PL202200086

Creekridge I
7807 Creekridge Circle

Expand existing deck for Additional exits on east side of building

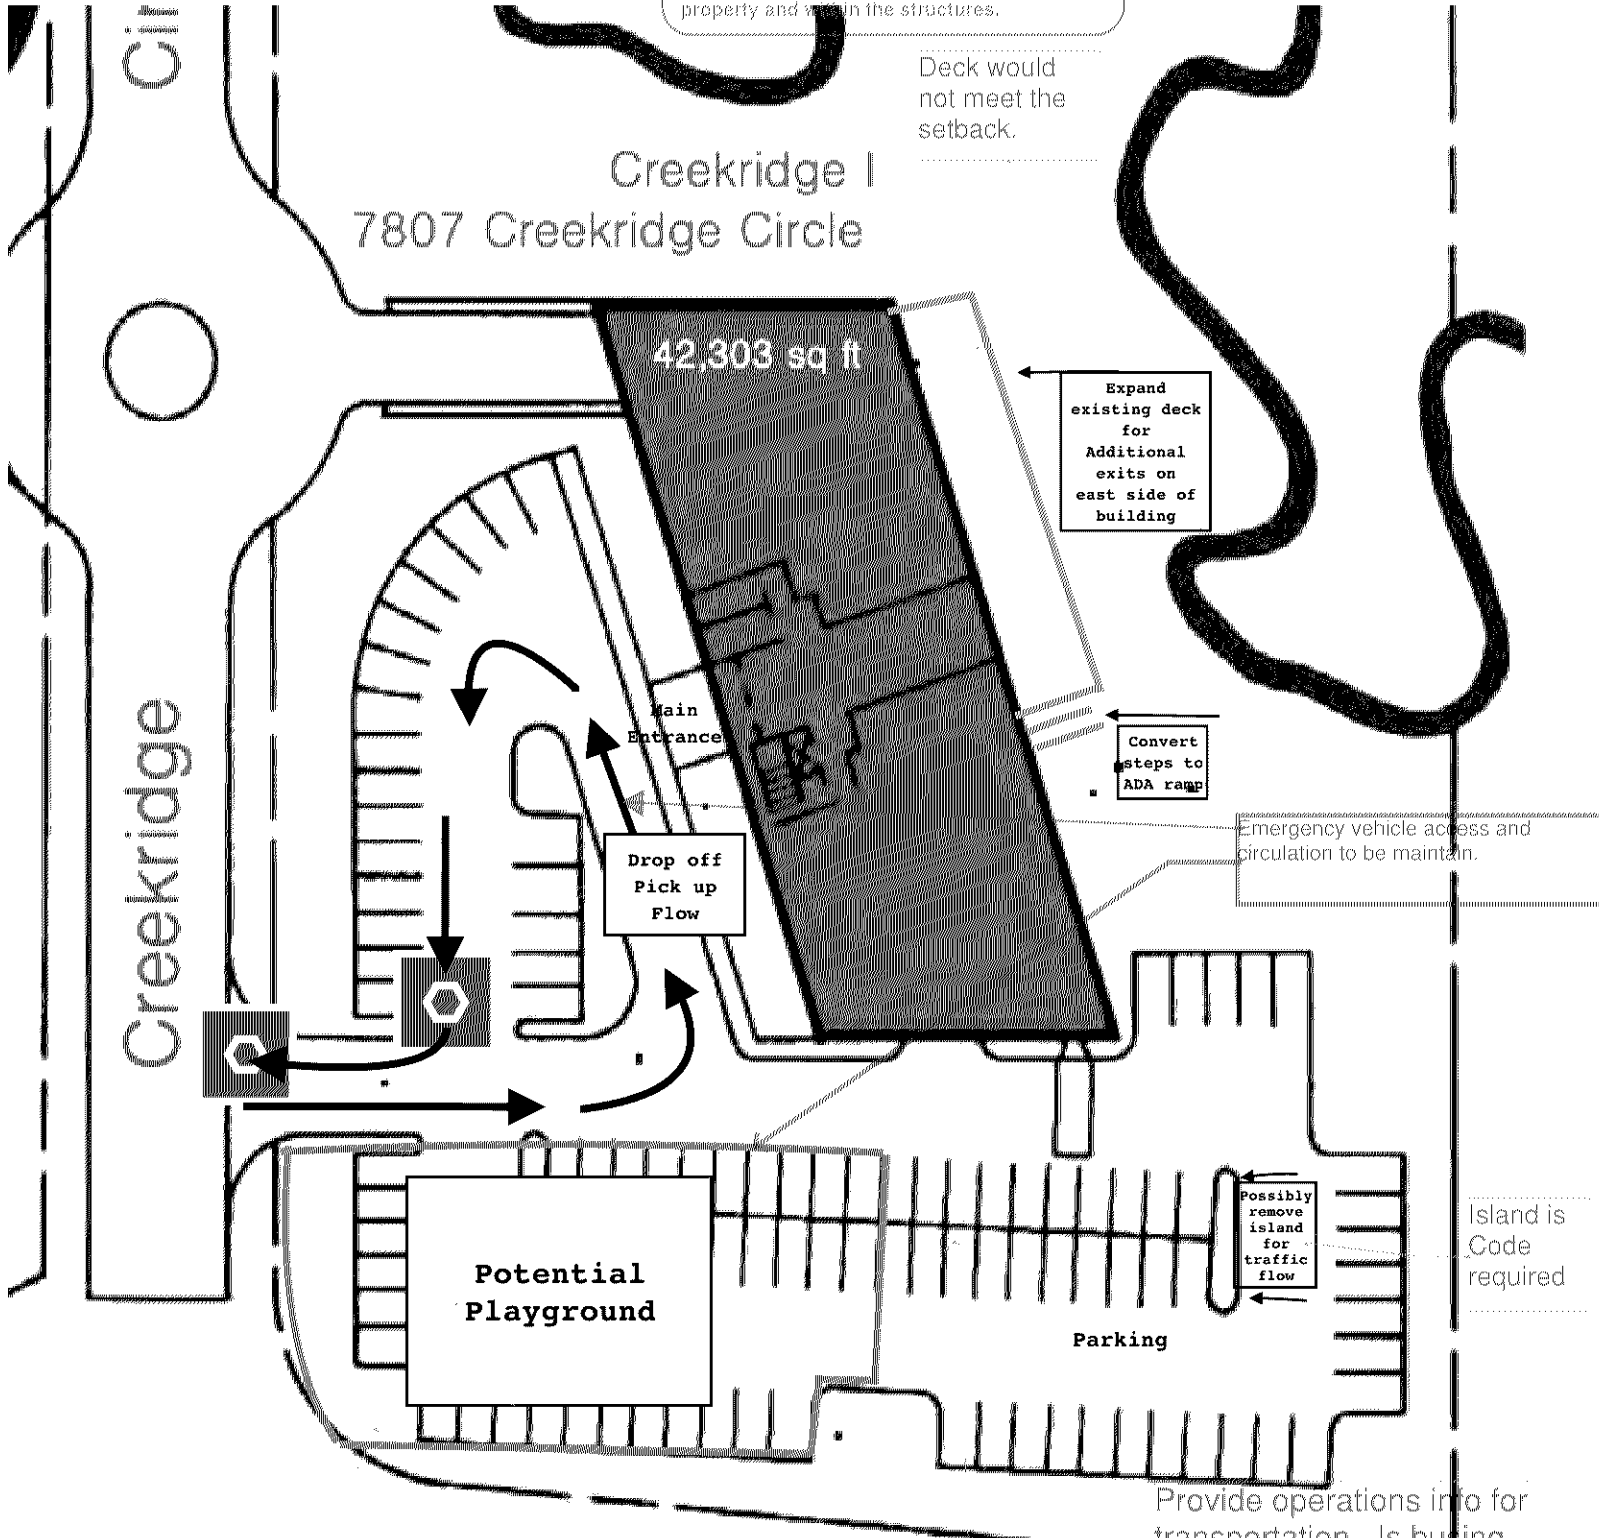
Building property shall be adequately signed for emergency response.

Provide adequate turning radius for all emergency vehicle access lanes.

Show property and easement lines.

Emergency responder radio coverage meeting the requirements of appendix L in the 2015 MSFC shall be provided throughout the property and within the structures.

Deck would not meet the setback.

Emergency vehicle access and circulation to be maintain.

Island is Code required

More detail required. Yard area must be maintained.

Circulation must be provided and must include an island

Provide operations info for transportation. Is busing provided? Layout should provide separated drop off and pickup between buses and parent traffic. Estimate and accommodate for parent traffic queue.

3RD FLOOR • 16,041 RSF

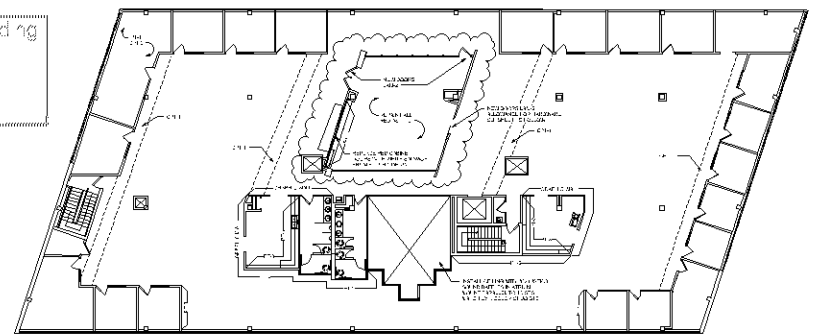
Entire space(s) must have fully Code complying sprinkler protection.

1ST FLOOR • 11,660 RSF

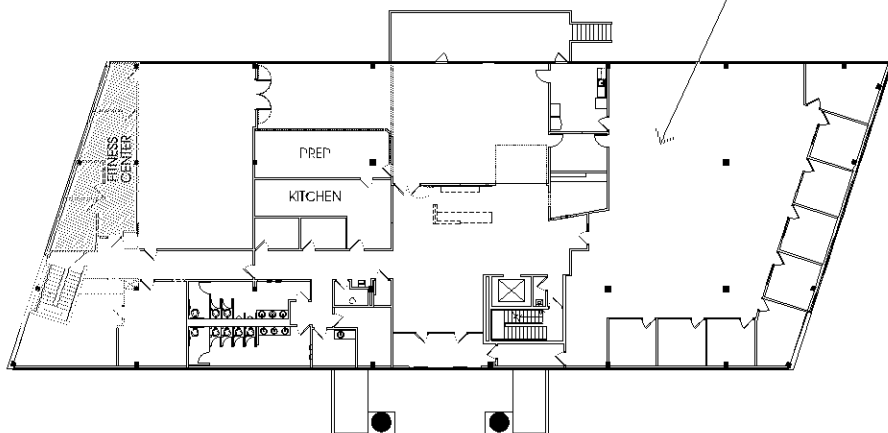
Cafeteria to meet 2020 MN Building Code for exiting requirements.

Provide an Environmental Health Plan Review application with plan submittal for each proposed food facility.

Any additions or changes to food service must be approved by the Health Department prior to construction if required.
